31398 Huntwood Ave. Hayward, CA 94544 (510) 576-2220  <a href="http://www.gelpak.com">www.gelpak.com</a>	
		<b>Description:</b> GEL-PAK Print# P-0041-HA (20x20, High Accuracy)	
<b>Part #</b> P-0041-HA		<b>REV:</b> 1	
<b>Dwg #</b> P-0041-HA_VR76-195.ai		<b>Date:</b> 9/10/08	
<b>Scale:</b> 1:1	<b>Dimensions:</b> Inches	<b>Sheet:</b> 1 of 1

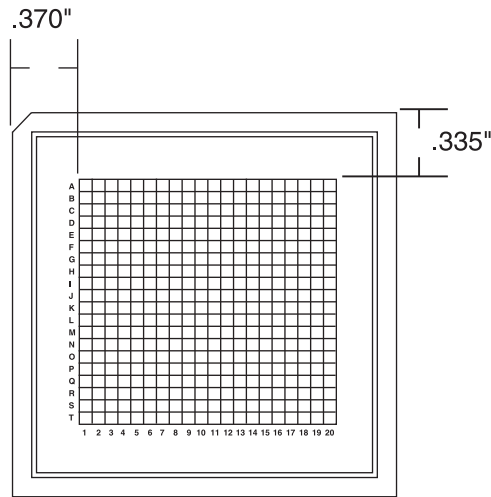
9/10/08 - Change tolerance from +/- 0.005" to 0.007"  
 Added MicroVu inspection requirement.

Note: High Accuracy = +/- 0.007" registration relative to top/left sides.  
 Must use MicroVu for First Article and In Process Inspections.
